ND-2012-0018
March 15, 2012

Subject: **PSEG Early Site Permit Application**
Docket No. 52-043
Response to Request for Additional Information, RAI No. 43, Vibratory
Ground Motion

Enclosure 1: Response to NRC Request for Additional Information, RAI No. 43, Question Nos. 02.05.02-1 and 02.05.02-4, SRP Section: 2.5.2 – Vibratory Ground Motion

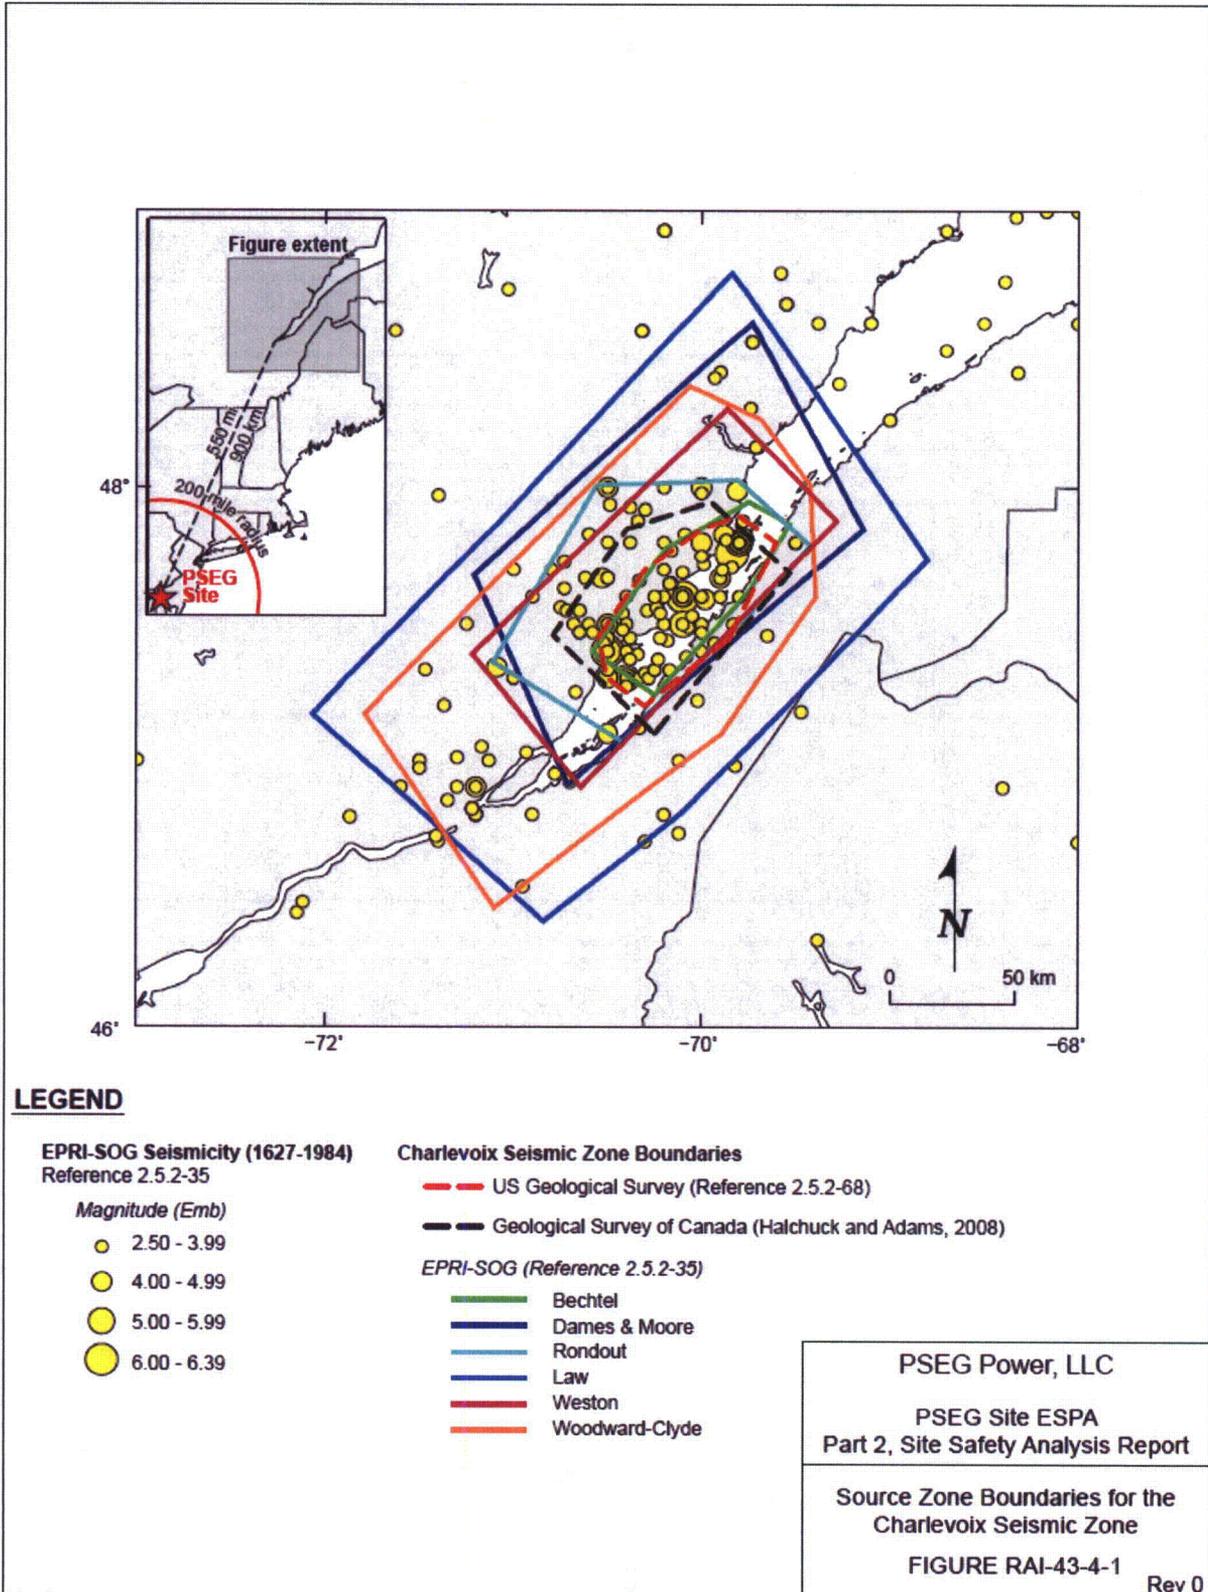
- a. SSAR Subsection 2.5.2.2.2 states that while the latest USGS PSHA study used new seismic model parameters for their Charlevoix seismic source, such as a lower b value, the EPRI-SOG source model was not updated because this update does not represent new information. In recent years, however, there has been significant new information on the nature of the Charlevoix and St. Lawrence rift seismic sources which might require updates to the original EPRI model. Please describe new findings described in the literature since the EPRI model and discuss how this new knowledge impacts the seismic hazard curves calculated for the PSEG site. Additionally, address the effect of the 1988 Saguenay M5.9 earthquake and its potential relationship to the Charlevoix and St. Lawrence rift seismic sources and source zone updates.*

Based on these types of observations, the CSZ generally is defined based on the distribution of seismicity and potentially related geologic features (impact structure, lapetan faults) within the region. Figure RAI-43-4-1 shows the EPRI-SOG seismic sources for the CSZ, the USGS characterization of the CSZ (SSAR Reference 2.5.2-68), the Geological Survey of Canada (GSC) zone for the CSZ (Reference RAI-43-4-15), and the EPRI-SOG seismicity. The figure shows that both the EPRI-SOG zones and the more recent zones encompass the same central cluster of seismicity in the St. Lawrence valley, but some of the EPRI-SOG zones extend further from the concentration of seismicity within the center of the seaway (e.g., see the Rondout, Woodward Clyde, and Dames & Moore zones). In most cases the drawing of a larger zone was intentional and reflects the interpretation of the teams that the potential source of large CSZ earthquakes was not limited to the region with the highest seismicity rates. For example, the Woodward Clyde team intentionally drew their zone larger in an attempt to encompass the intersection of the impact structure and the rift faults (SSAR Reference 2.5.2-34, vol. 8, p. B-7). Similarly, the Dames & Moore team recognized the high seismicity region of the CSZ as being much smaller than the zone they drew deciding to also capture the tectonic features associated with rifting and the impact structure (SSAR Reference 2.5.2-34, vol. 6, p. A56-A57). Based on the reasoning of the EPRI-SOG teams that defined broader zones for the CSZ, the newer information regarding the CSZ (e.g., more recent earthquakes, refined earthquake locations, new hypotheses on the causative faults for earthquakes within the CSZ) is not justification to alter the geometry of the EPRI-SOG zones. If the geometry of the EPRI-SOG zones were modified to more closely resemble the USGS or GSC zones, the changes would not cause a significant increase in hazard at the PSEG Site given the low contribution to hazard from the CSZ and the considerable distance between the zones and the PSEG Site (500 to 600 mi., 800 to 970 km).
